SUBJECT: SUSQUEHANNA STEAM ELECTRIC STATION, UNIT 1 (TAC NO. M99481)

AMENDMENT TO FACILITY OPERATING LICENSE

Amendment No. 174  
License No. NPF-14

SAFETY EVALUATION BY THE OFFICE OF NUCLEAR REACTOR REGULATION

Figure 2.1.2-1  
MCPR Safety Limit vs Core Flow

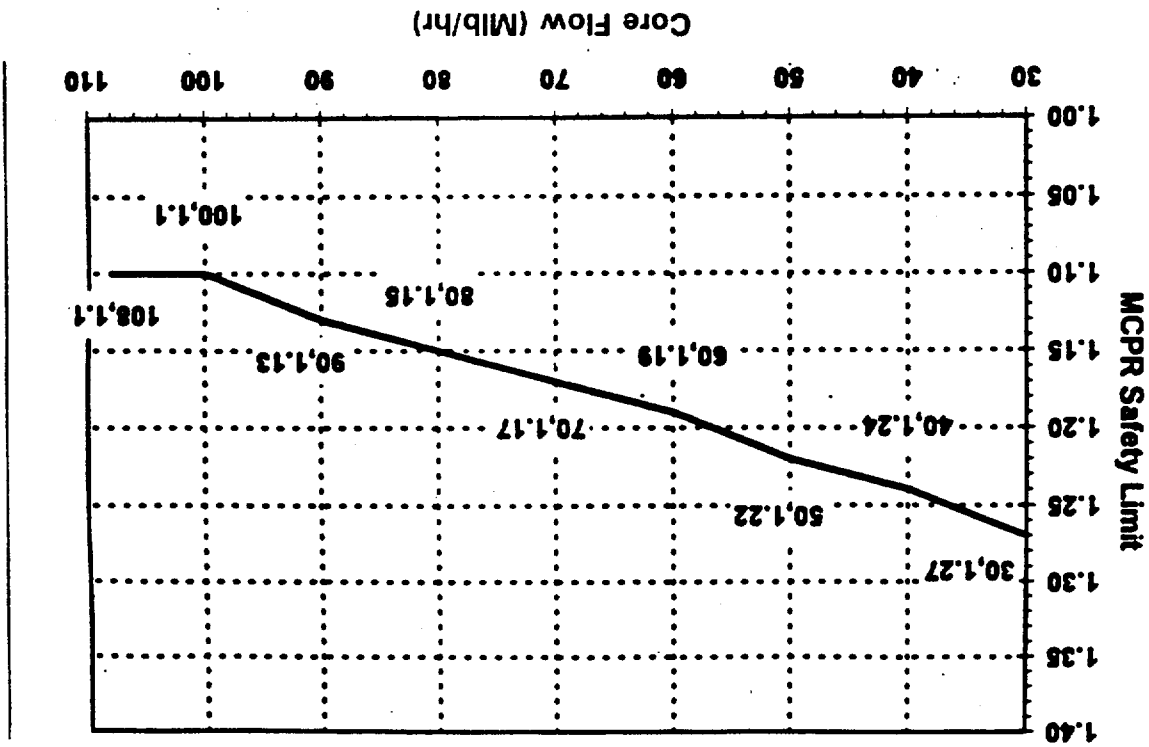
The MINIMUM CRITICAL POWER RATIO (MCPR) shall not be less than the value shown in Figure 2.1.2-1\*\* with the reactor vessel steam dome pressure greater than 785 psig and core flow greater than 10 million lbm/hr.

With MCPR less than the value shown in Figure 2.1.2-1\*\* and the reactor vessel steam dome pressure greater than 785 psig and core flow greater than 10 million lbm/hr., be in at least HOT SHUTDOWN within 2 hours and comply with the requirements of Specification 6.7.1.

The safety limit MCPR in TS 2.1 is proposed to change from 1.08 to the value shown in Figure 2.1.2-1 ( $\geq 1.11$  depending on the core flow) for operation with two recirculation loops with the reactor vessel steam dome pressure greater than 785 psig and core flow greater than 10 million lbm/hr., and from 1.09 to the value shown in Figure 3.4.1.1.2-1 ( $\geq 1.22$ ) for single loop operation

The staff has reviewed the proposed changes to TS Sections 2.1.2 and 3.4.1.1.2 and has found them acceptable since they are based on the analyses performed using S1C11 cycle-specific inputs and approved methodologies in References 4 and 5 and PP&L's conservative actions to restrict single-loop operation.

Figure 3.4.1.1.2-1  
MCPR Safety Limit vs Core Flow  
Single Loop Operation

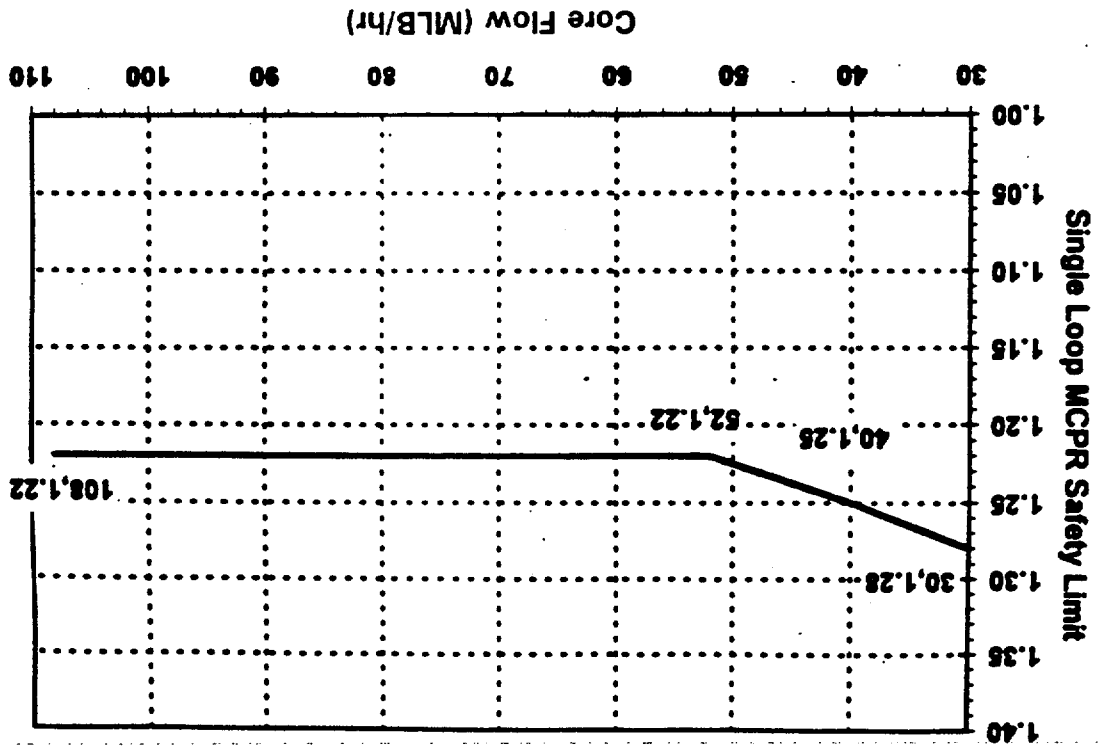
1. Specification 2.1.2: the MCPR Safety Limit shall be increased to the value shown in Figure 3.4.1.1.2-1\*\*.

(SLO) based on the cycle-specific analysis of a modified ANFB core performed by SPC for S1C11 mixed core of ATRIUM™-10/SPC 9x9-2 fuel. However, PP&L noted that the SPC methodology did not examine the bottom 3 feet of the fuel bundle in determining the ANFB predicted critical power. PP&L, in dealing with this issue, took conservative action and imposed administrative controls by changing the applicable General Operating procedure, the Off-Normal Operating procedure and the system-specific Operating Procedure to preclude single-loop operation or to impose conditions limiting the time in single loop operation until resolution of this issue (References 3, 7 and 9).
